Notice of Intent

Type of Action: APD Change

Form 3160-5
(June 2019)UNITED STATES
DEPARTMENT OF THE INTERIOR
BUREAU OF LAND MANAGEMENTFORM APPROVED
OMB No. 1004-0137
Expires: October 31, 2021**SUNDRY NOTICES AND REPORTS ON WELLS**
Do not use this form for proposals to drill or to re-enter an abandoned well. Use Form 3160-3 (APD) for such proposals.

XTO respectfully requests approval to make the below listed changes to the approved APDs.

Previous Design: 4-String Design – Engineered Weak Point**[Figure F] 4 String – 2nd Intermediate casing engineered weak point**

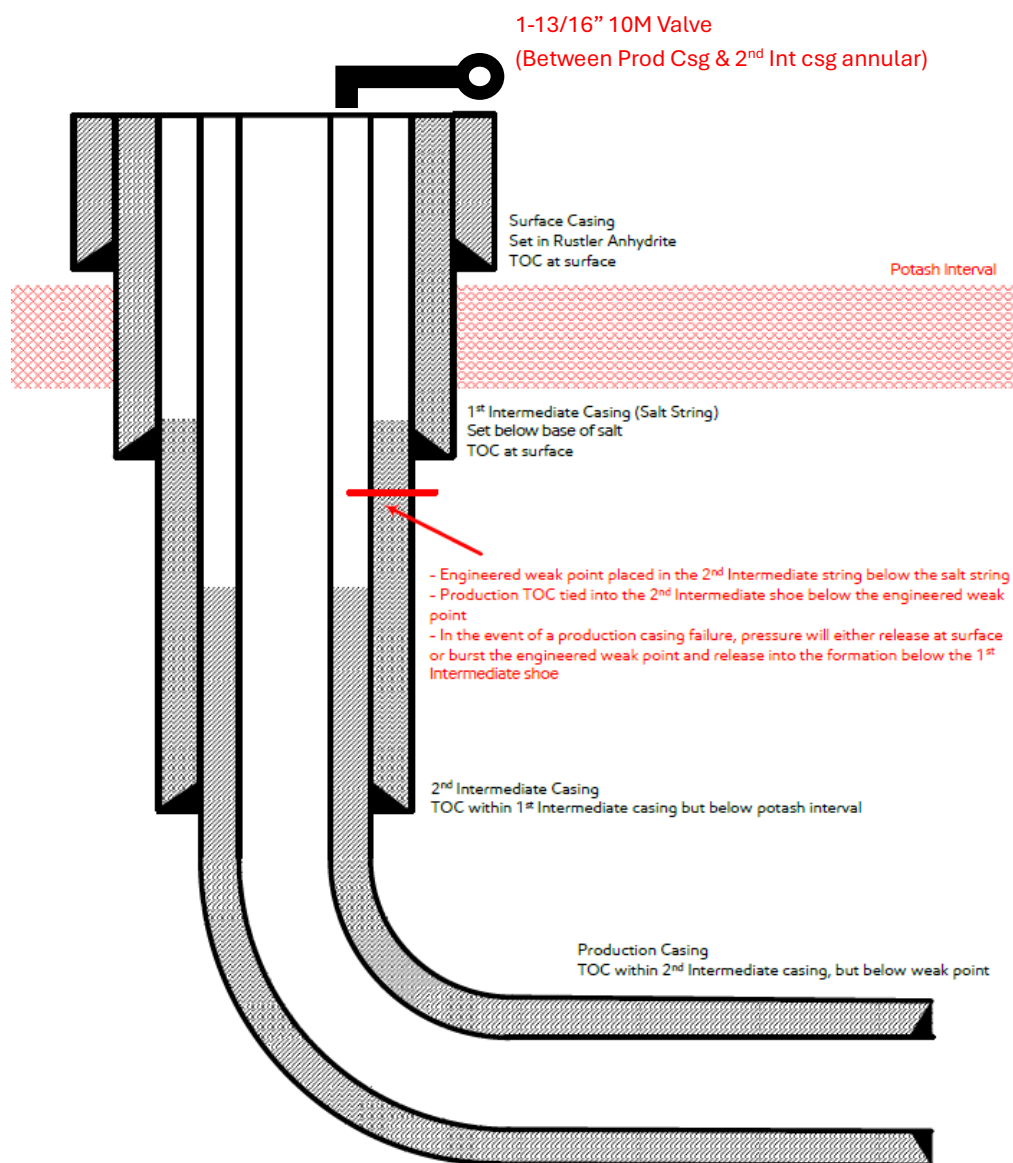
1. Casing design to be changed from the "4-String Design – Engineered Weak Point" (FIGURE F) to the "4-String Design – Open 1st INT x 2nd INT Annulus" (FIGURE D). An open annulus will be utilized and monitored during completions operations.

- 1) Alignment with KPLA requirements per schematic per schematic below, with engineering weak point casing design and utilizing new casing that meets API standards.
- 2) Contingency plans in place to divert fluids away from salt interval in event of production casing failure.
- 3) Intermediate 2 casing will consist of a primary cement job with TOC at the top of the Brushy Canyon formation within the Delaware Mountain Group.
 - a. Bradenhead squeeze to be completed after primary cement job to tie back TOC to intermediate 1 "Salt string" at least 500' but with top below Marker Bed 126 "Potash Interval".
- 4) Production cement to be tied back no less than 500' inside previous casing shoe (intermediate 2 casing) and below the engineered weak point.

New Proposed Design: 4 – String Design – Open 1st Int X 2nd Int Annulus (ICP 2 below relief zone)**[Figure D] 4 String – Uncemented annulus between 1st and 2nd intermediate casing strings**

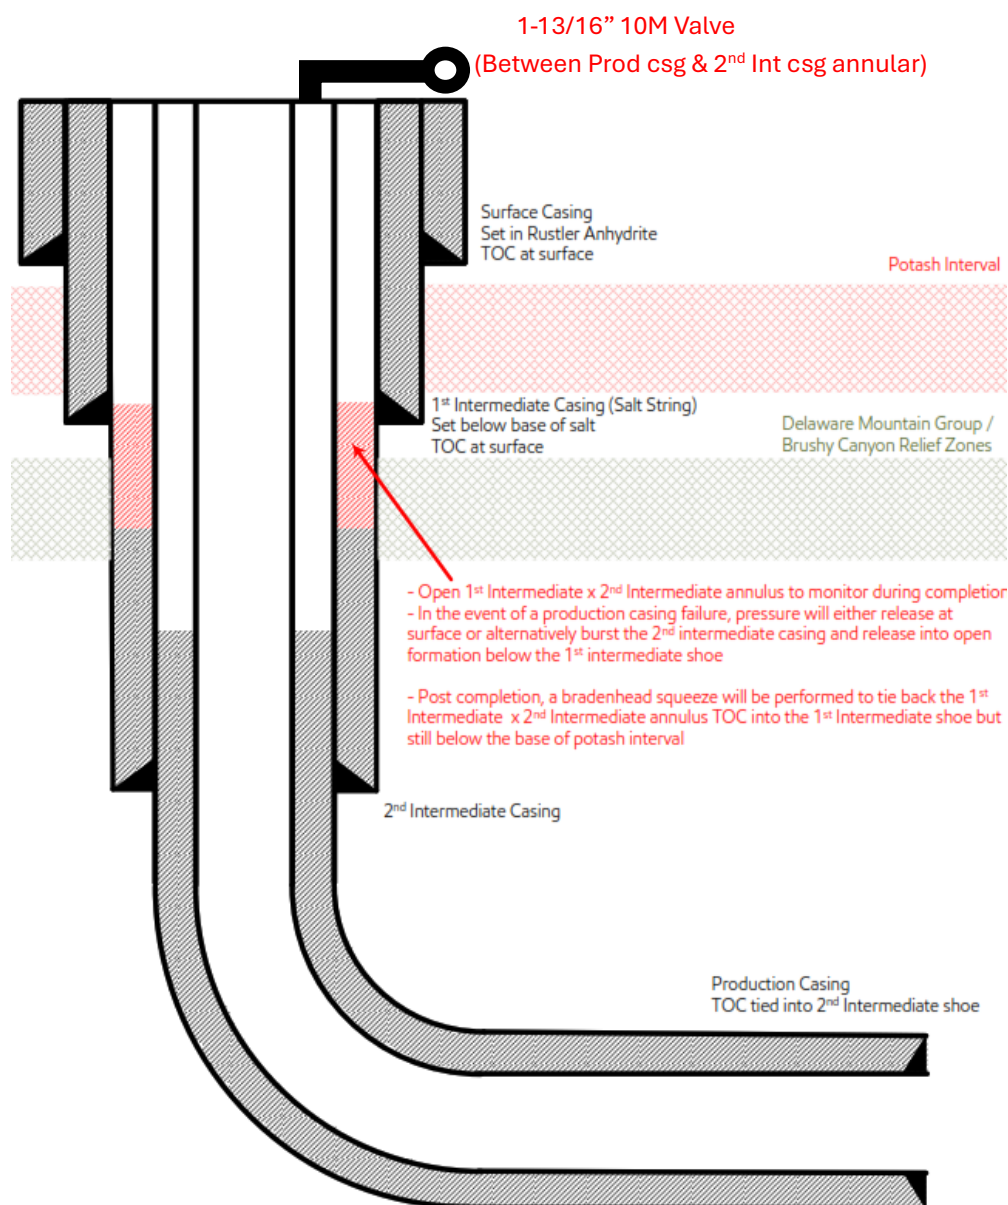
Post completion, bradenhead squeeze will be performed to tie back the 1st intermediate x 2nd intermediate annulus. TOC will be placed into the 1st intermediate shoe but still below the base of Potash interval.

- 1) Alignment with KPLA requirements per schematic above, leaving open annulus open for pressure monitoring during frac and utilizing new casing that meets API standards.
- 2) Contingency plans in place to divert fluids away from salt interval in event of production casing failure.
- 3) Intermediate 2 bradenhead squeeze to be completed within 180 days to tieback TOC to salt string at least 500ft but with top below Marker Bed 126.
- 4) Production cement to be tied back no less than 500ft inside previous casing shoe.
